Urgent Field Safety Notice

Subject: Liko® Viking® L, Viking® M, Viking® XL, and Viking® 300 Mobile Lifts – Potential Actuator Damage

FSCA-identifier: Mod 1228

Type of action: Corrective Action Notification

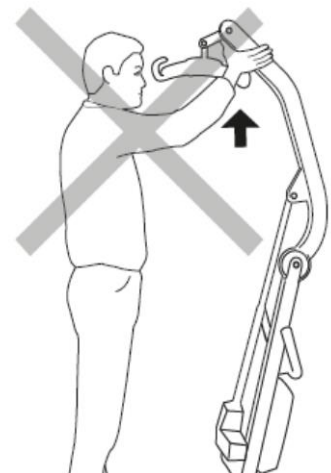
Hill-Rom has received 9 complaints where it is alleged that the lift arm drifted down suddenly on certain Viking® Mobile Lifts.

This issue is preceded by users who lift the lift arm assembly manually, as shown in the illustration to the right.

The lift arm assembly is intended to only be lifted by the actuator (lift motor). If the lift arm assembly is manually lifted, the actuator can become damaged and get stuck in the highest position. When the actuator is stuck, the lift cannot be raised/lowered by the lift motor. If a patient is lifted into the sling while the actuator is stuck, there is a potential risk of a free fall of the patient. This hazard could cause minor or potentially catastrophic injuries to a patient if the free fall encompasses the entire stroke of the actuator.

Hill-Rom requests customers not to raise the lift arm manually since the lifting actuator can become stuck and/or become damaged. Always use the hand controls or the control box to operate the lift. There are no hazards when using the device as intended. Hill-Rom is updating the product labelling to address this hazard.
